RE: PROPOSED DEVELOPMENT OF STOCKTONS, GREAT ANCOATS STREET, MANCHESTER ("the Proposed Development")

GIA are instructed to respond to the further daylight objection from the residents of Oxygen Towers, Store Street, Manchester ("Oxygen") and Urbanbubble Limited, which has been prepared by Akt. Rights to Light Surveyors Ltd ("AKT") and is dated 17 December 2025 ("the Stage 2 DS Review").

Oxygen Towers – between 18.5m and 22.9m from the Proposed Development

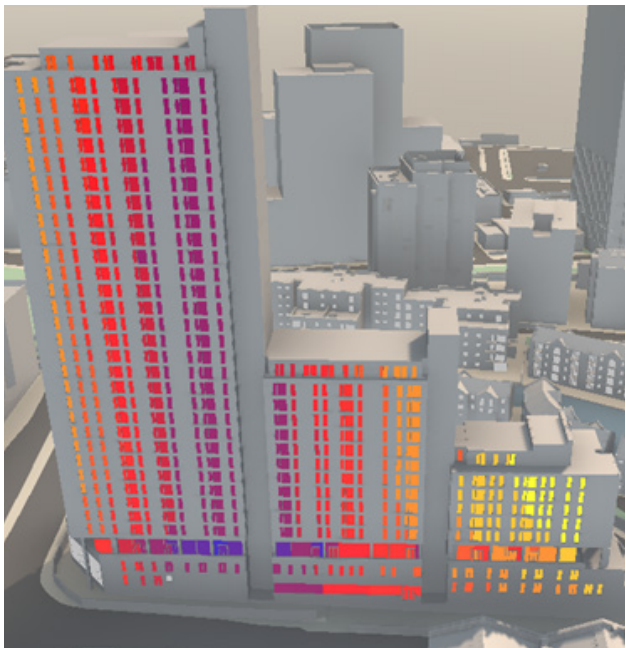
Sky visibility levels range between 3.0% and 39.6%
The average amount of visible sky for the building is 15.9%
